APPLICATION NO.	FILING DATE	FIRST NAMED INVENTOR	ATTORNEY DOCKET NO.	CONFIRMATION NO.
10/722,156	11/24/2003	Raj B. Apte	D/A3536	6774

Office Action Summary

DETAILED ACTION

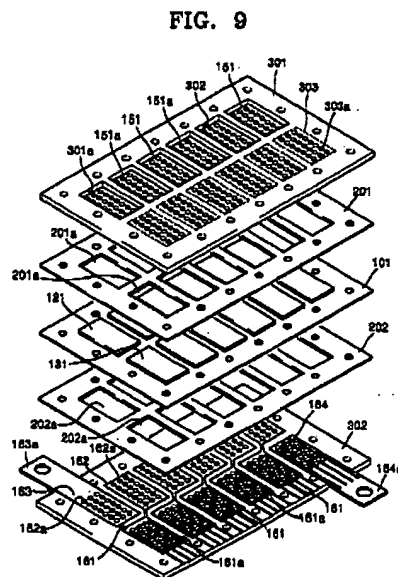
With respect to **claim 27**, Choi teaches a fuel cell comprising: an electrolyte (col. 8, lines 25-35) having a first side; a manifold cover (201) that is in contact with the electrolyte (101), the manifold cover (201) and electrolyte (101) together form two manifolds, a first manifold including an anode (121), and a second manifold including the cathode (131), wherein the two manifolds are both on the first side of the electrolyte. See Figure 9.

FIG. 6

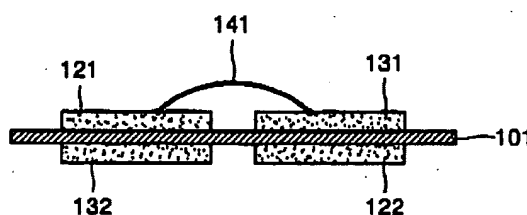
With respect to **claims 29 & 32**, the anode (121) and the cathode (131) are in a first plane, the first plane is approximately parallel to the first side of the electrolyte (101). See Figure 6.

FIG. 2

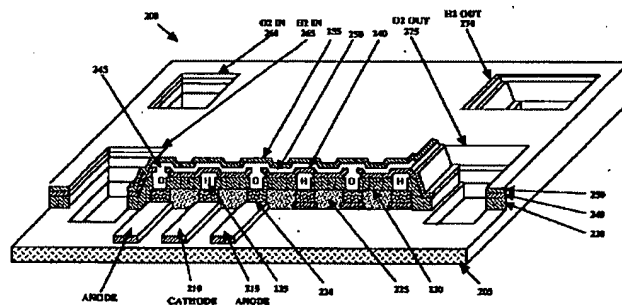
With respect to **claim 27**, Potter teaches a fuel cell 200 comprising: an electrolyte (225) having a first side; a manifold cover (205) that is in contact with the electrolyte (225), the manifold cover (205) and electrolyte (225) together form two manifolds, a first manifold including an anode (215), and a second manifold including the cathode (210), wherein the two manifolds are both on the first side of the electrolyte. See Figure 2, and paragraph 49.

With respect to **claims 29 & 32**, the anode (121) and the cathode (131) are in a first plane, the first plane is approximately parallel to the first side of the electrolyte (101). See Figure 2.

With respect to **claim 34**, the first side of the electrolyte (225) includes a first indentation and a second indentation, wherein each include an anode and cathode, respectively. See Figure 2 and paragraph 49.

With respect to **claim 36**, the manifold cover is in contact with an edge of the electrolyte indentations containing electrodes. See Figure 2 and paragraph 49.
